RECORD DRAWINGS (July 2013)  
INFORMATION PROVIDED BY:  
Rogers-O'Brien Construction Company

**TRAFFIC SIGNAL SUPPORT STRUCTURES MAST ARM POLE DETAILS**

**MA-D-12 (DAL)**

**POLE ELEVATION**

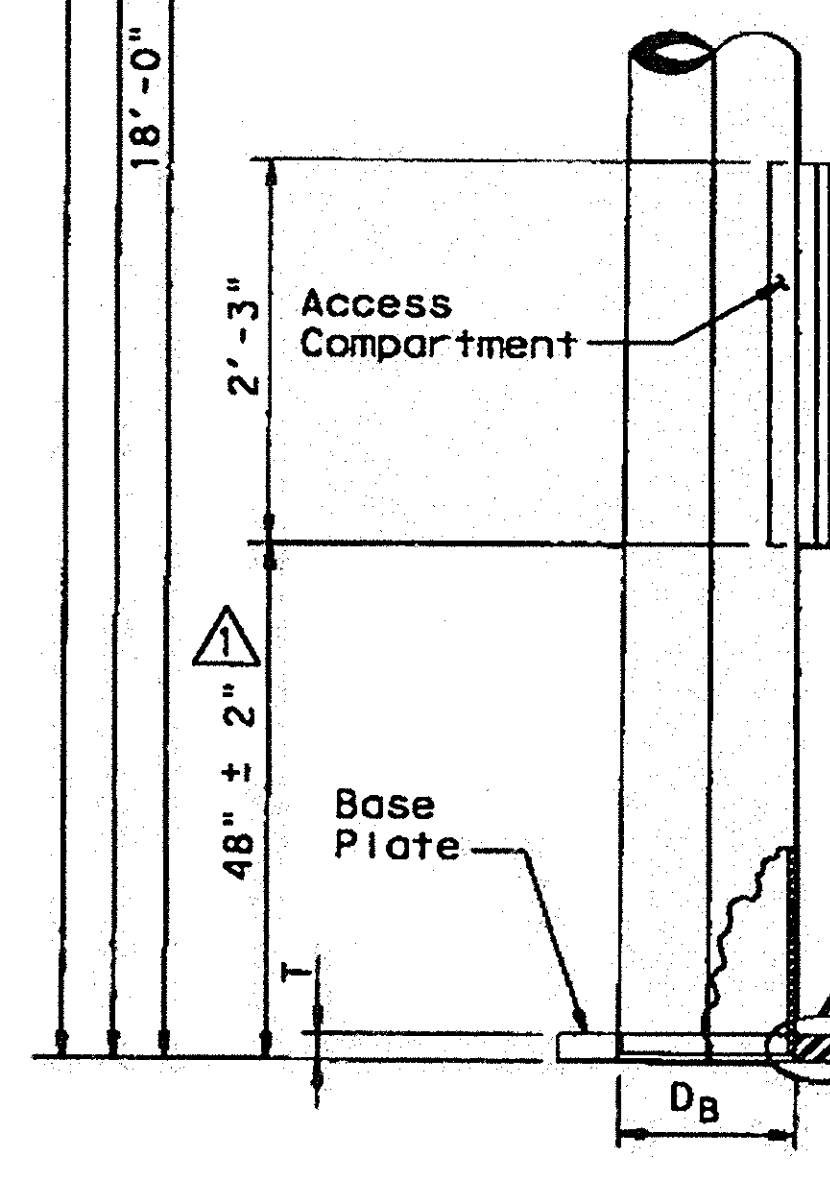
REVISD THE ELEVATION OF ACCESS COMPARTMENT (2/12).
